TO: T10 Membership
FROM: Paul A. Suhler, Quantum Corporation
DATE: 17 February 2009
SUBJECT: T10/08-409r8, ADT-2: Internet ADT (iADT)

Changes to ADT-2 rev. 5

Figure 34 — Example Media Changer application of ADT

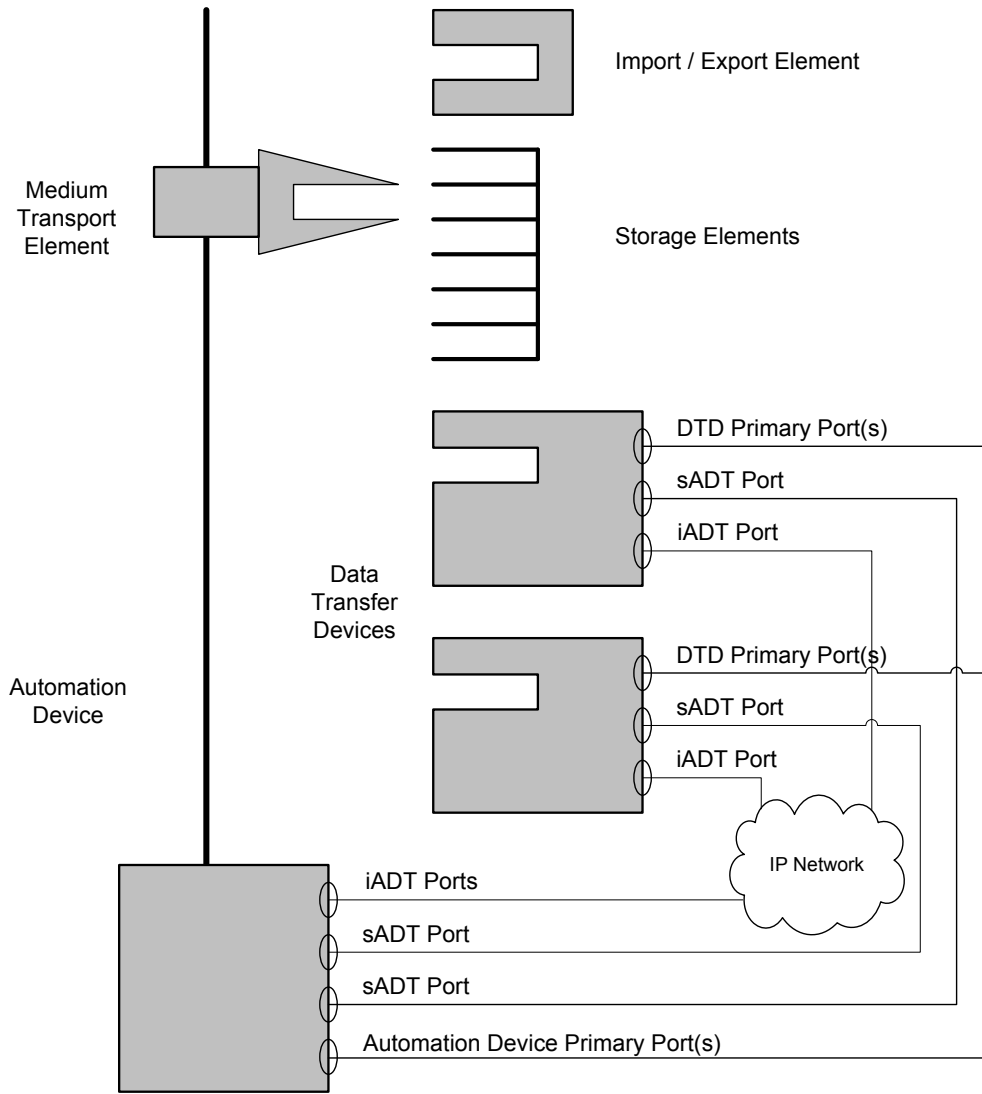
Figure 3.4 shows ~~an example of an ADT interface~~ examples of serial ADT (sADT) and internet ADT (iADT) interfaces (see 4.1.2) within a media changer containing two DT devices. Other common components of a media changer are also shown for reference. The components of an automation device are medium transport elements, data transfer (DT) devices, storage elements, and import/export elements (see SMC-3). The automation device may communicate with the DT devices through ADT ports, as defined in this standard. DT devices and automation devices communicate with initiator ports other than those in the automation device using primary ports.

Note: A media changer or DT device would not necessarily contain both sADT and iADT ports. They are both shown for comparison.

Replace and renumber Figure 3:

4.3.2.5.2 Transition P3:Logged-out to P0:Initial

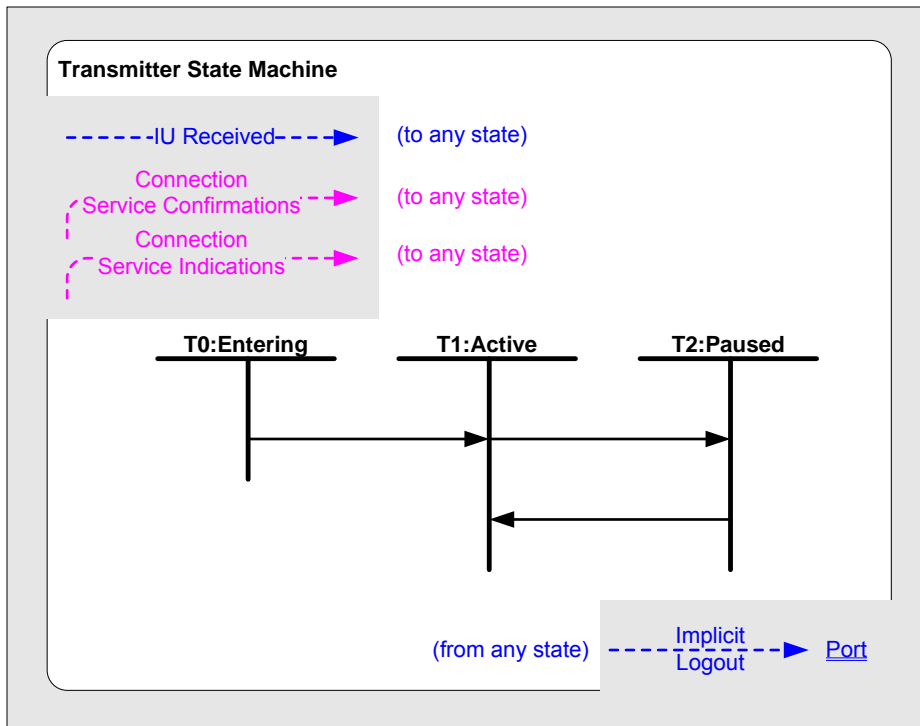
A port shall transition to P0:Initial after the logout duration time ~~specified in the Port Logout IU (see 6.5.5)~~ has expired.
